OPEN SPACE ADVISORY COMMITTEE STAFF REPORT

MEETING DATE: February 22, 2016

REQUEST: **For Possible Action:** To approve the wetlands enhancement project at the old Buzzy's Ranch property as designed by Ducks Unlimited.

LAHONTAN VALLEY / WESTERN NEVADA WETLANDS I NAWCA - BUZZY'S RANCH PROJECT WETLAND RESTORATION / ENHANCEMENT

PROJECT NO. US-NV-33-7	DATE: 1/6/2016	DESIGNED BY: JR
BUZZY'S RANCH PROJECT		DRAWN BY: JS
WETLAND RESTORATION / ENHANCEMENT		SURVEYED BY: JM
		CHECKED BY:
		SHEET NO. 5 of 7

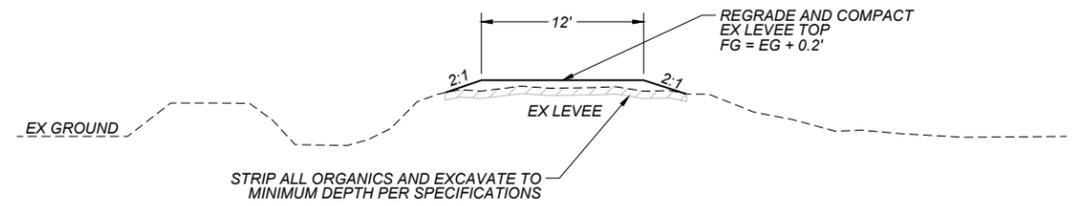
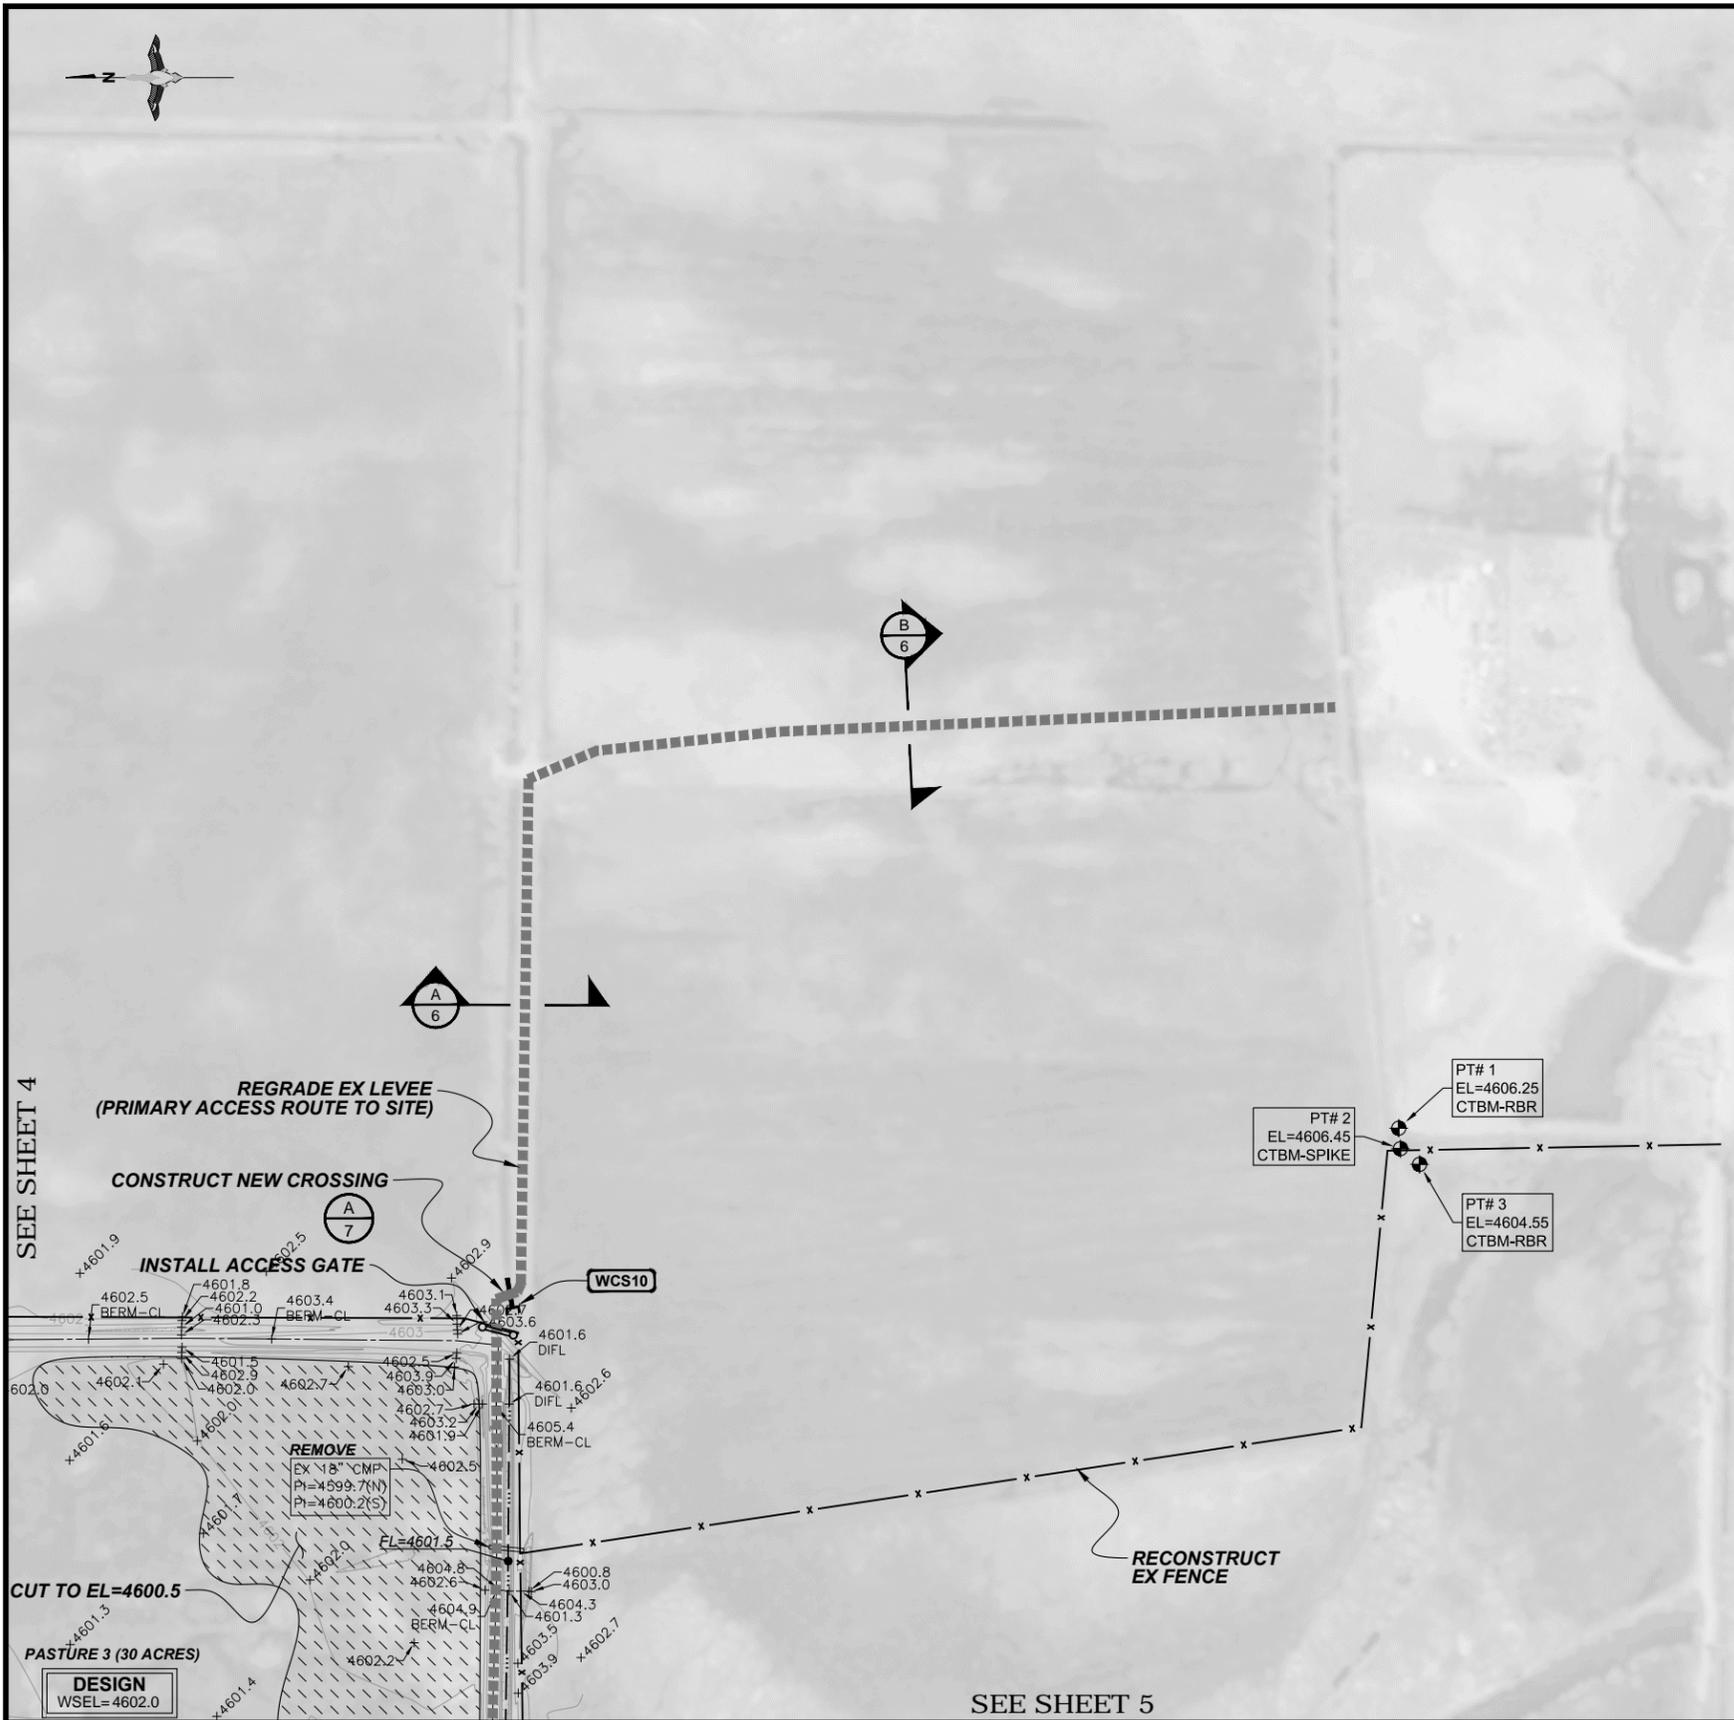
- How much potential water (___ CFS) will be going through the structure on page 5? It's an 18" structure which can hold 7 CFS if the slope is flat. It can hold more with more slope. Clarification on the amount of water anticipated would help clarify the design.

- The concrete sill – just a thought – most of it is underground with 0.5 foot above ground. If you make that permanent concrete, that is not moveable. When things change you will be stuck with that elevation not sure how important that might be but other material that can be adjusted might be considered depending on your concern.

- Depths of ponds should be deeper which would provide more dirt to use elsewhere and would take advantage of shallow water table to seep into the pond, thereby keeping tules from growing.
- What is the operation plan for the project and how will it impact grazing or stock water access? (Timing, schedule, access, duration and overall operation).
- Sheet No. 4 Recommend removal of old pipe if it is not needed for function of project.
- Sheet No. 4 WCS01 Need access to cross ditch to open head gate.
- Sheet No. 4 WCS02 Appears to show a different length pipe and the head gate is in the ditch. This ditch does not carry enough water to fill anything.
- Sheet No. 5 Plans show existing fence repair and this fence does not exist and would

- Sheet No. 5 Plans show no fence and this should be added as a new fence.
- Sheet No. 5 There is no access to the wetlands and in early discussions there were two 14' gates and one 12' gate to allow for grazing and access to stock water.
- Sheet No. 5 Do not recommend rebar grate because it will constantly be plugged up with trash and debris.
- Sheet No. 5 Prefab cement drop structure seems too expensive and may plug up. You should consider gabions or an open stepped down drop structure.
- Sheet No. 6 Recommend organic material placed with re-seeding along all levees.
- Sheet No. 6 Recommend 6' of compacted material on temporary road not 12'. Too much material for a temporary access road and will require less material to be excavated or disturbed.
